ALEX ROARK ENGINEERING

APRIL 14, 2024

Alex Roark Engineering has reviewed the Transportation Analysis for the proposed TradeWinds Island Grand Resort development prepared by Lincks & Associates, Inc. dated March 28, 2024 and we offer the following comments. Based on the comments below, to accurately reflect an analysis of the transportation conditions, the study will need to be revised.

TABLE 4
2029 BACKGROUND TRAFFIC

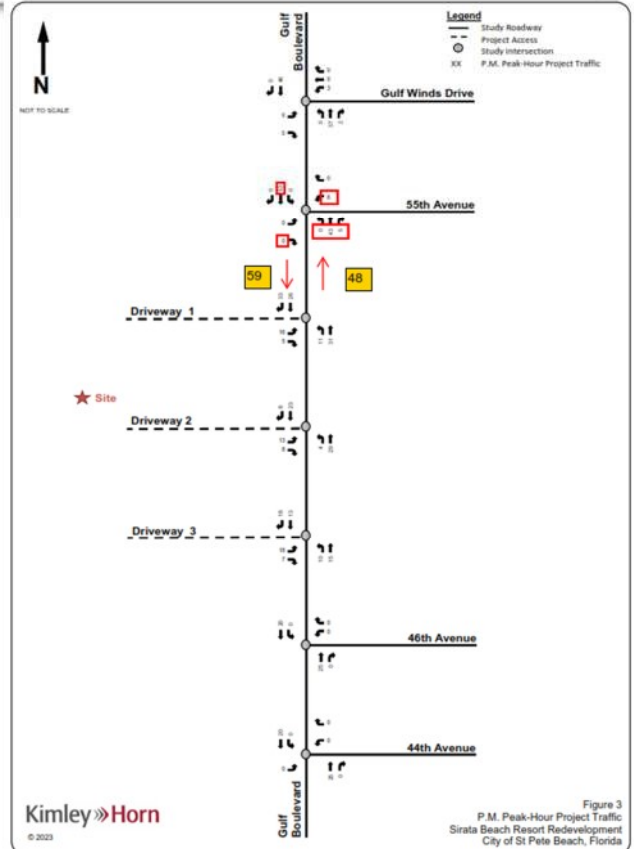
b. The volumes on Gulf Boulevard from the TradeWinds to the Pinellas Bayway link from the Sirata Resort traffic analysis is wrong.

When selecting a volume from a roadway link with multiple segments, the highest volume should be selected. Notwithstanding the other errors from the Sirata Resort traffic analysis itself, the volumes pulled from that report on that segment were 24 northbound and 20 southbound. However, it should be 48 northbound and 59 southbound since the segment just south of 55th

Avenue has these volumes in the Sirata study.
